SERVICE BULLETIN

No. 229A

Piper Aircraft Corporation

SUBJECT: Removal of Restriction to Airspeed Limits

SKETCH A

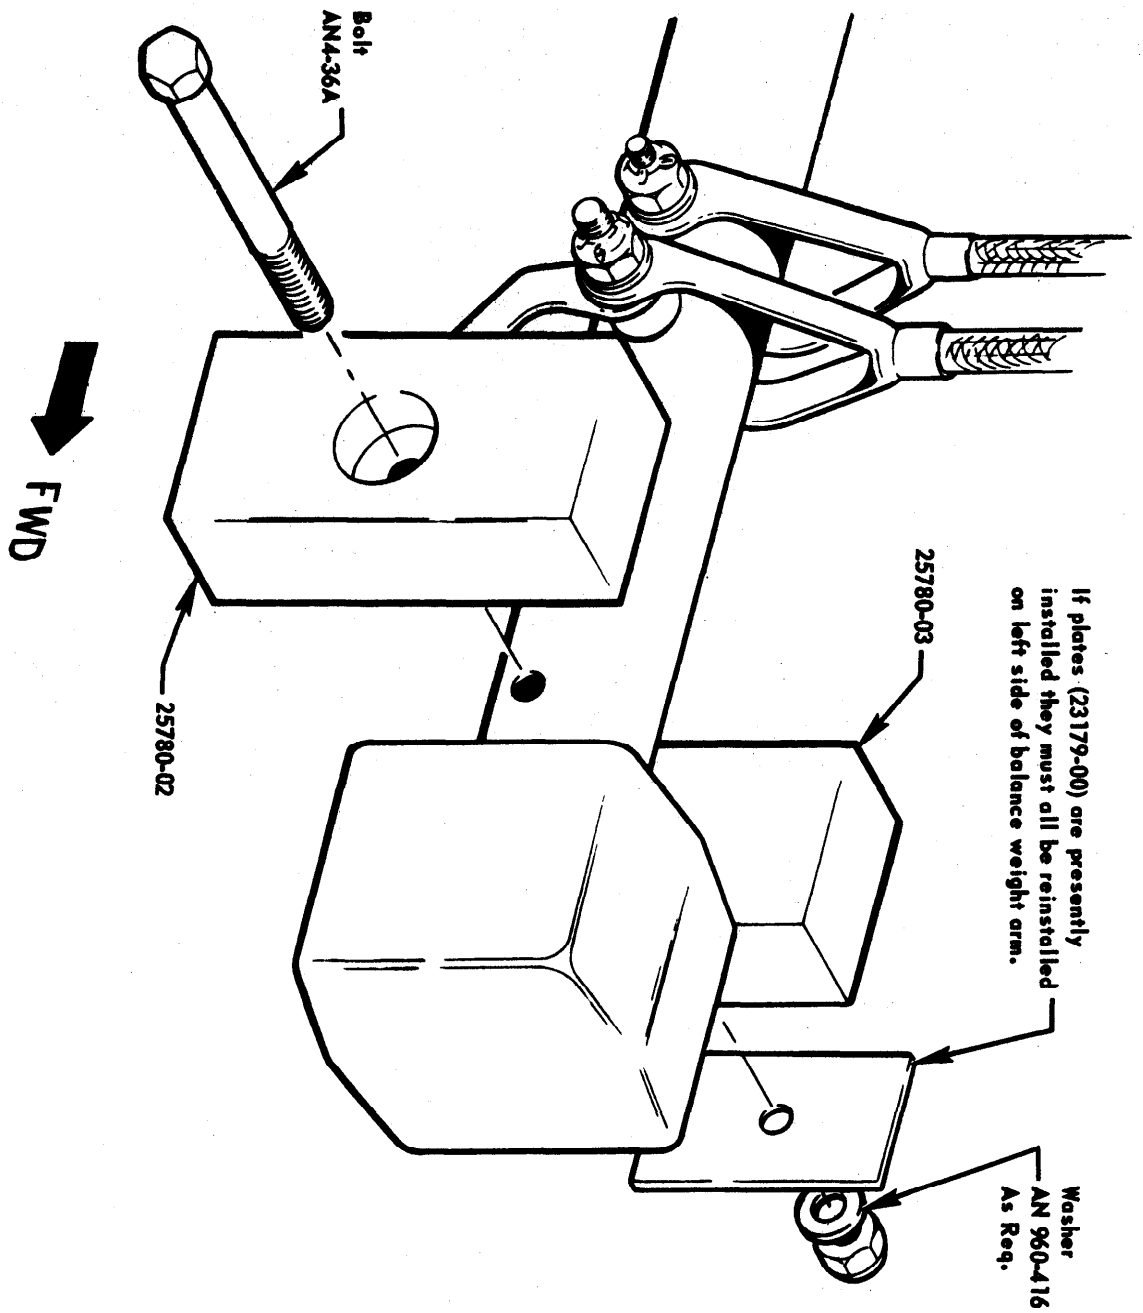
It has been determined that the installation of balance weights, part numbers 25780-02 and 25780-03 in addition to the standard balance weight, part number 23594-00, will eliminate this vibration, however, the original never-exceed airspeed limit, 245 MPH, must be reduced to 240 MPH.

A placard for the airspeed indicator, a revised Flight Manual, Stabilator Balance Weights and an AN4-36A bolt are contained in Kit 757 044. Information concerning the installation of this kit is contained on sketch "A" attached to this bulletin.

If plates (23179-00) are presently installed they must all be reinstalled on left side of balance weight arm.

PLACARD SK1814

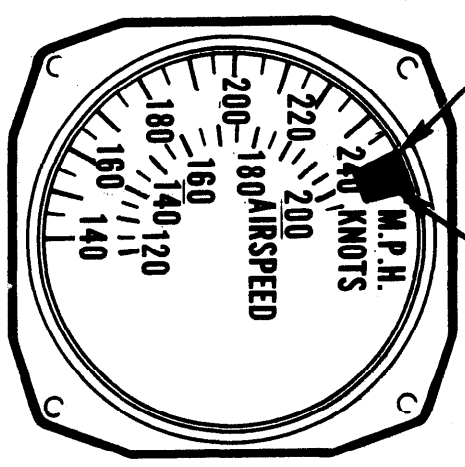
The Airspeed Indicator Placard SK-1814 contained in Kit 757 044 must not be installed on aircraft equipped with Brittain Industries Tip Tanks model No. TT-5 since these aircraft are restricted to a 230 MPH never-to-exceed speed limit. However, the balance of the requirements contained in this bulletin remain effective.

LOCATE THIS EDGE OF PLACARD AT 240 M.P.H.

SKETCH B

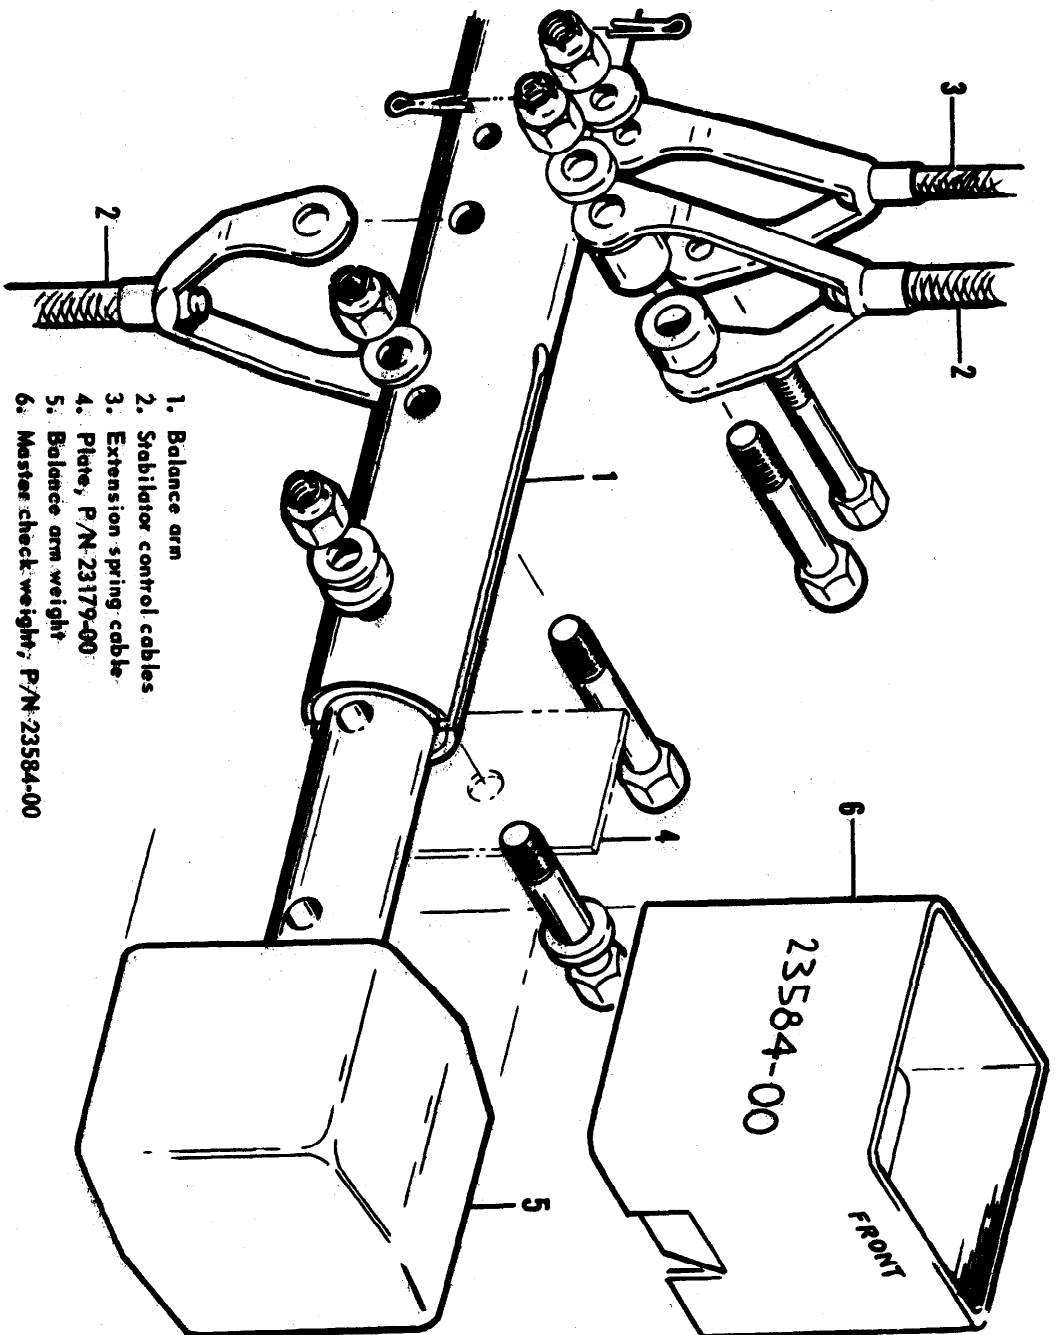
c. Master check weight 23584-00 (weight 1.58 pounds) should be placed on top of balance weight 23594-00 with the side marked "FRONT" facing forward. If this is not enough weight to obtain static balance with the balance arm level, plates 23179-00 must be added to the forward balance weight attachment bolt until 100% static balance is obtained or until up to two plates more than that required for balance have been added. It should never be necessary to use more than eight plates. If a total of more than eight plates are necessary to obtain balance, the manufacturer should be consulted.

e. After balancing is accomplished, the check weight should be removed and the front attachment bolt connecting the stabilator balance weight to the stabilator balance arm shall be removed and weights, part nos. 25780-02, 25780-03 and bolt AN4-36A and stabilator balance weight plates 23179-00 shall be installed at this attachment point. Stabilator balance weight, part no. 25780-02 shall be installed on the right side of the stabilator balance arm and stabilator balance weight, part no. 25780-03 and stabilator balance weight plates 23179-00 shall be installed on the left side of the stabilator balance arm.

Balance weight, part no. 25780-02 shall be installed such that the counter-bore and bolt head face outboard on the right side of the balance arm.
